REZONING
SITE PLAN
FOR
DR. LOUIS TOTTH

PETITION NO: Z-21

Z-21

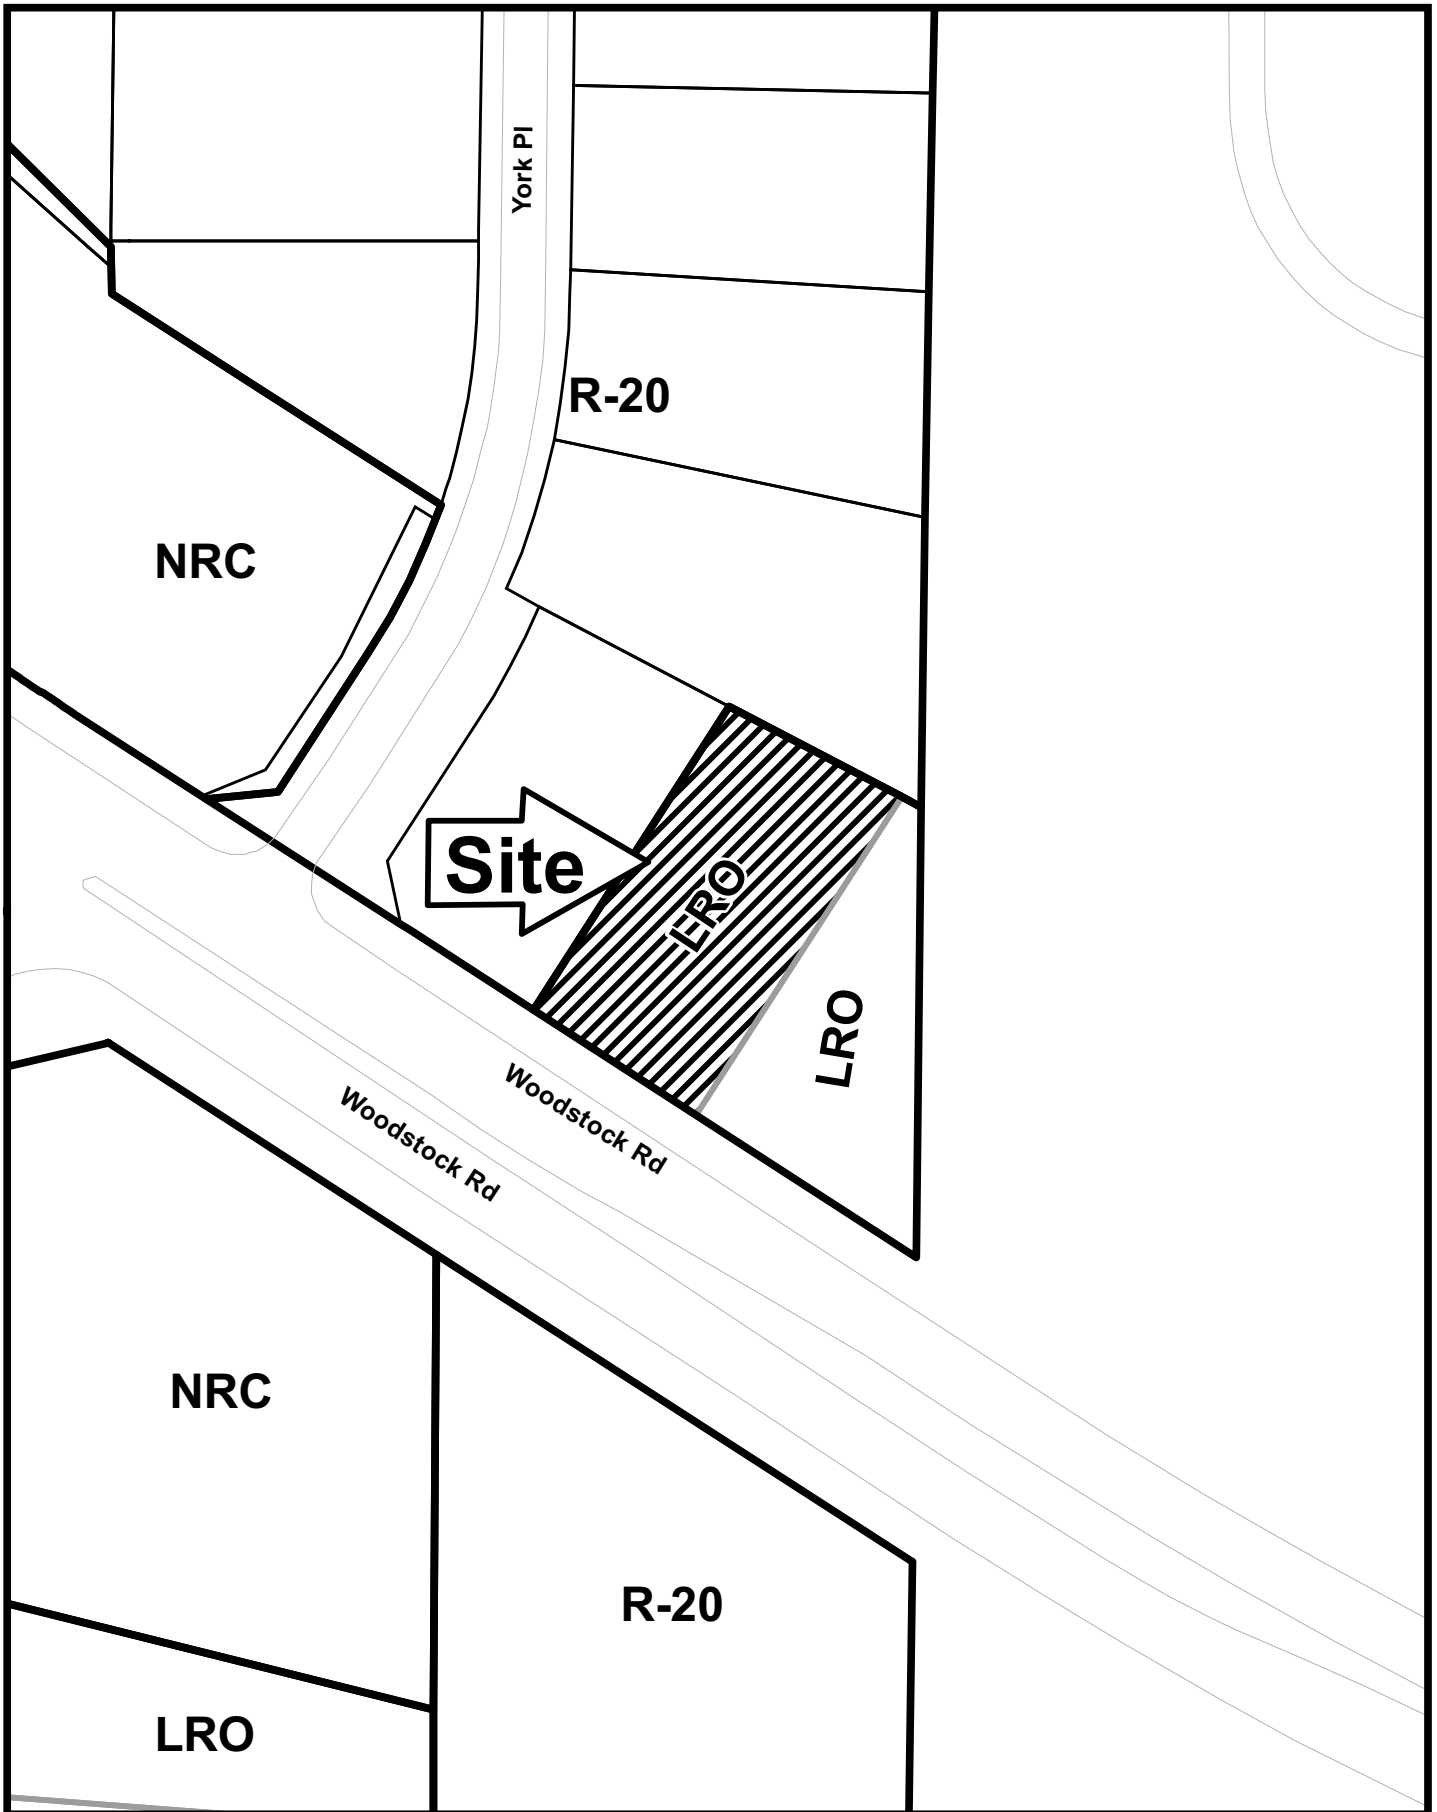
- No Stormwater controls shown _____
- Copy of survey is not current – Additional comments may be forthcoming when current site conditions are exposed.
- No site improvements showing on exhibit.

1. No site improvements are proposed at this time. Any future improvements must meet current Stormwater Management requirements.
